Planning Commission Staff Report

October 12, 2011
Item 6.b.

- SUBJECT:** PSPA-04/PUD-65-01M
- APPLICANT:** Nick Kavayiotidis, Petra Realty Investors, Inc.
- PROPERTY OWNER:** Nick Kavayiotidis
- PURPOSE:** Applications for: (1) an amendment to the North Sycamore Specific Plan and Planned Unit Development (PUD) Major Modification to allow a memory care/assisted living facility as a permitted use and (2) PUD Development Plan to construct an approximately 21,481 square foot, one-story memory care/assisted living facility containing 46 beds. Also consider the Negative Declaration prepared for this project.

- LOCATION:** 5980 and 5998 Sunol Boulevard
- GENERAL PLAN:** Retail, Highway, and Service Commercial; Business and Professional Offices.
- ZONING:** Planned Unit Development – Office (PUD-O) District.

Proposed Site Plan

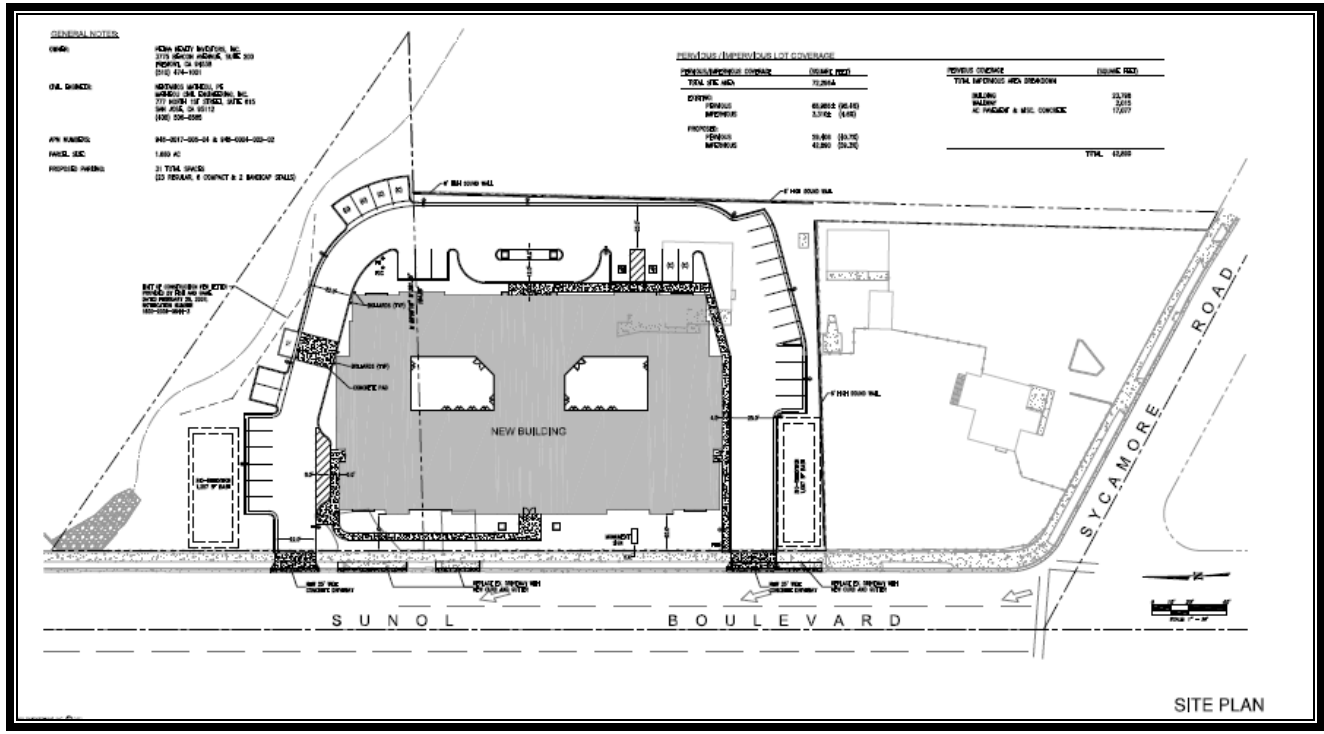
The proposed landscaping plan shows a narrow two-foot wide planting strip along the east property line opposite to the proposed compact parking spaces. This planting strip width could be increased by approximately two feet as the required drive aisle width is 25 feet. As shown on the site plan, the drive aisle width between the planting strip and the compact parking spaces is approximately 27 feet wide. Staff has previously discussed this revision with the applicant and the applicant agreed to this revision. A condition has been included to address this item.

The proposed parking areas are broken into smaller components as they are located in three areas. There is no parking proposed between the building and Sunol Boulevard. Therefore, the parking lot design meets the NSSP regulations.

Staff believes that the proposed positioning of the building towards Sunol Boulevard with parking located on the sides and rear of the building presents an attractive appearance from Sunol Boulevard. Furthermore, the building location provides substantial setbacks from the adjacent residences. In addition, as noted above, staff believes that the proposed location of the parking areas complies with the NSSP requirements. The proposed 29.53 percent FAR would meet the FAR of the NSSP.

As previously discussed, a condition has been added requiring the width of the eastern planting strip be increased. Thus, the final landscape plan would be subject to the review and approval by the Community Development Director.

Building Design

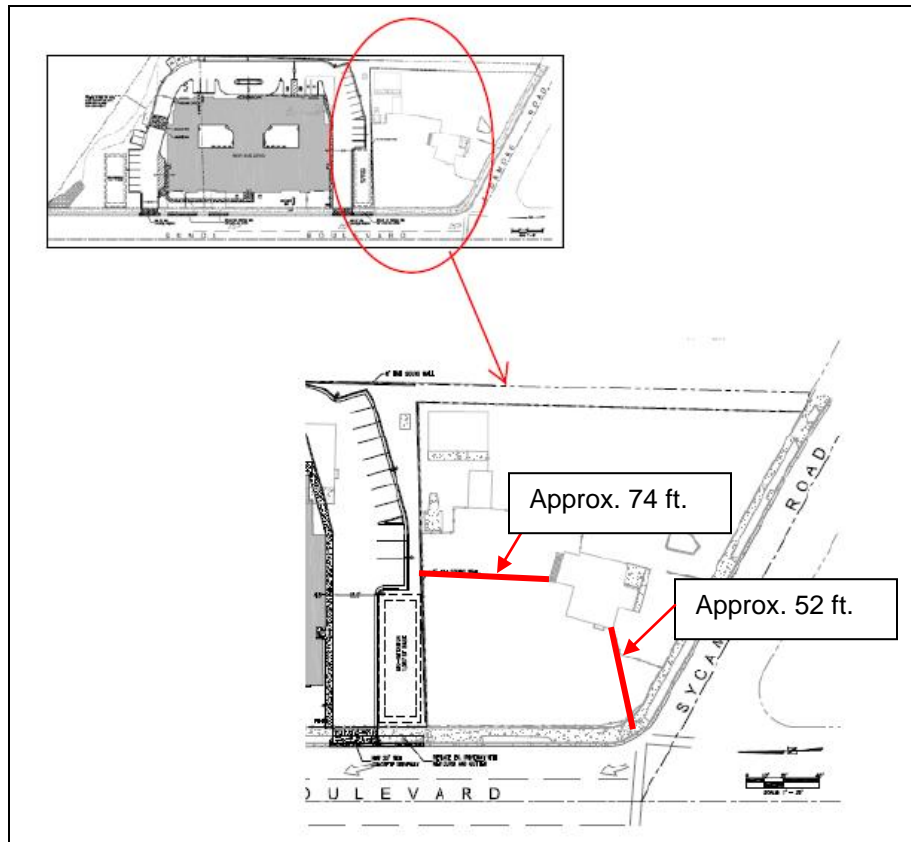
The subject site is a sensitive one due to its proximity to the adjacent residences and its frontage on a major City thoroughfare. Therefore, staff worked with the applicant to design a building with high quality architecture and materials. Although the building entrance is on the rear (east) elevation, its west elevation incorporates design details, such as stone columns and a centered, gabled projecting area with a large window which provides visual entry on the Sunol Boulevard frontage. Having the building entrance on the east side avoids parking and drive aisle between the building and Sunol Boulevard ; therefore, satisfies the design criteria of the NSSP concerning parking location. Staff believes that the building is attractive and contains design elements, described earlier, which break up its volume. Staff also believes that the building is well articulated and would be compatible with the surrounding buildings. The colors and materials of the building will complement the building architecture and would be compatible with other buildings in the area. Staff also finds the building height to be acceptable and compatible with the surrounding structures.

Landscape Plan

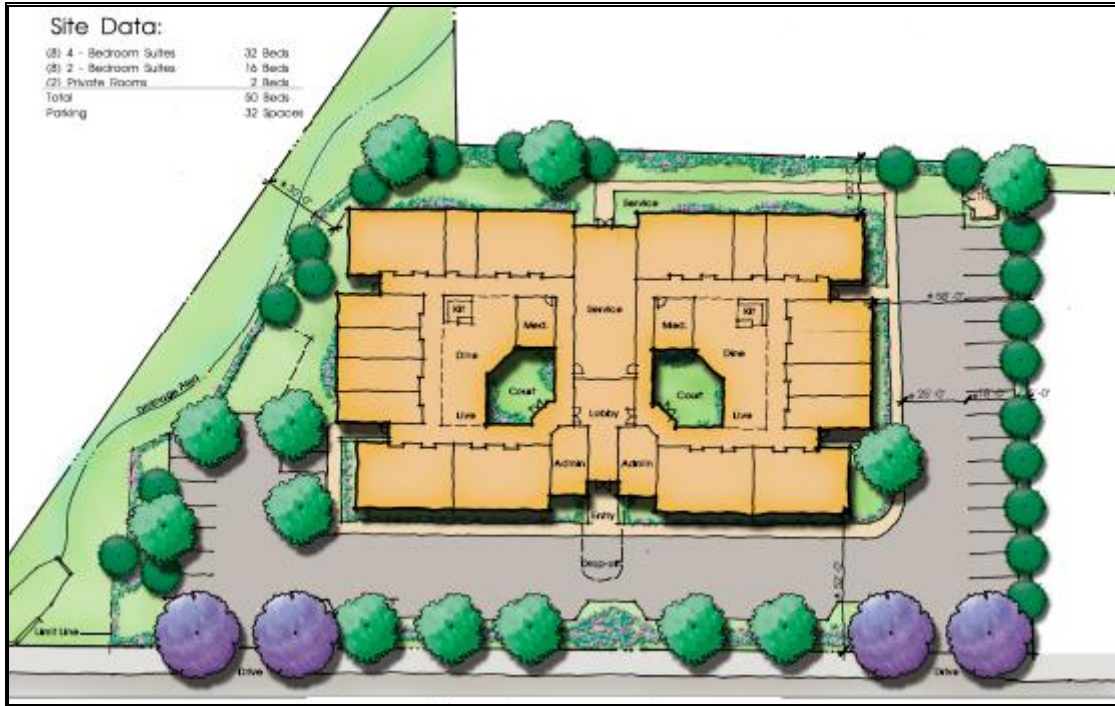
The landscape plan will provide a variety of trees, shrubs, and groundcover on the project site. Staff believes that the proposed landscape plan is attractive and contains sufficient landscape area around the perimeter of the building, parking areas, and along the street frontage. Staff also believes that the density and species of trees and shrubs indicated on the plan are generally appropriate.

Alternative Plan 2:

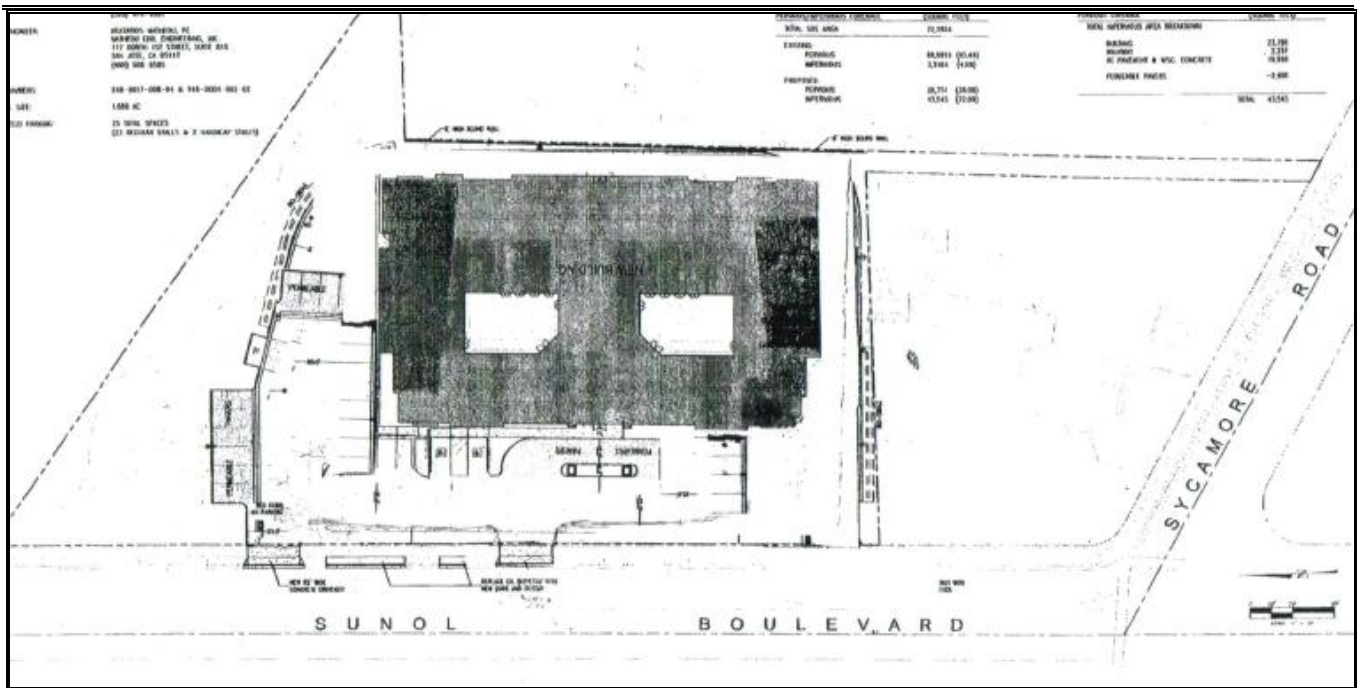
This plan was also reviewed by Livermore-Pleasanton Fire Department with the following comments:

- The south driveway would need to be relocated further south to allow fire access to the front drive aisle.
- Driveways would need to be sized to accommodate LPFD apparatus.
- Relocation of the south driveway would eliminate the need for a modified hammerhead.

Staff compared the current proposal with this alternative plan. This alternative does not provide adequate on-site parking spaces (it showed a total of 17 parking spaces); thus, may result in overflow parking into residential areas. Additionally, it would locate parking between the building and Sunol Boulevard, which would not conform to the NSSP design guideline which states that placing parking between the building and main street frontage should be avoided whenever possible.
